M. Collaud Coen et al.,

Determination and climatology of the planetary boundary layer height above the Swiss plateau by in-situ and remote sensing measurements as well as by the COSMO-2 model.

ACPD- 2014-314

The authors thank the three referees for their constructive comments that help us to greatly improve the clarity and the quality of the manuscript. In the following, all the comments are answered and the modifications introduced in the revised manuscript are described.

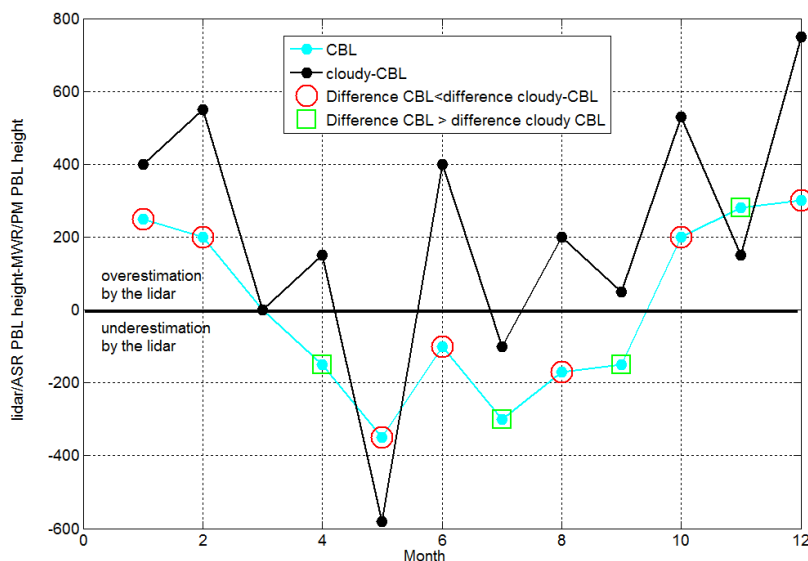
- The climatology of the CBL and cloudy CBL: in Fig. 9 and 10 you showed a very good agreement of Lidar and MWR for the cloudy CBL, but an underestimation for the CBL. That surprises me, due to the advantage of lidar in cases of cloud free, convective conditions. Where does this underestimation comes from?

The difference between lidar/ASR and MWR/PM PBL height is not really smaller for cloudy-CBL cases than for CBL cases. These difference are plotted on the next figure. It can be seen that:

- The difference for CBL cases are more regular, showing an overestimation by the lidar in winter and an underestimation in summer.
- The results for the cloudy-CBL cases are much more scattered, reflecting the great difference in the number of cases for the lidar and the MWR. The lidar cannot measure if there is too much or too low clouds. The comparison between the PBL detected by both method has therefore to be taken with great care for the cloudy-CBL climatology.

- The difference between the lidar/ASR and the MWR/PM PBL height is smaller for CBL cases for 7 months and larger for 4 months.
- Taken into account the uncertainties of both methods, we cannot really conclude that the lidar/ASR underestimate the PBL height (or that the PM overestimates it, which can also be possible due to the MWR uncertainties). The absolute differences are most of the time smaller than 200 m, which is similar to the uncertainty range.

The following atmospheric phenomena could also occur:

- The PM method considers an adiabatic rise of the air masses. In the atmosphere, there is probably a deviation of the adiabatic conditions and a mixing of the air masses during the rising up to the PBL top, leading to a lower altitude for the PBL measured by particle concentration than by theoretical convection conditions.

- The PM was applied to θ and not to θ_v . The PBL estimated from θ_v is higher than the one estimated from θ , since the water vapor is lighter than dry air. The consideration of the air moisture will involve higher PBL height and a greater difference between MWR/PM and lidar/ASR in summer, but a smaller one in winter.

- The particles are heavier than air masses and can perhaps stay at a lower altitude than air due to the gravity force, at least for the greatest particles such as mineral dust and pollens. This could explain the lower PBL height measured by the lidar/ASR.

I do not have however a clear estimation of the impact of these atmospheric phenomena and cannot therefore scientifically estimate their end effect on the PBL height determination.
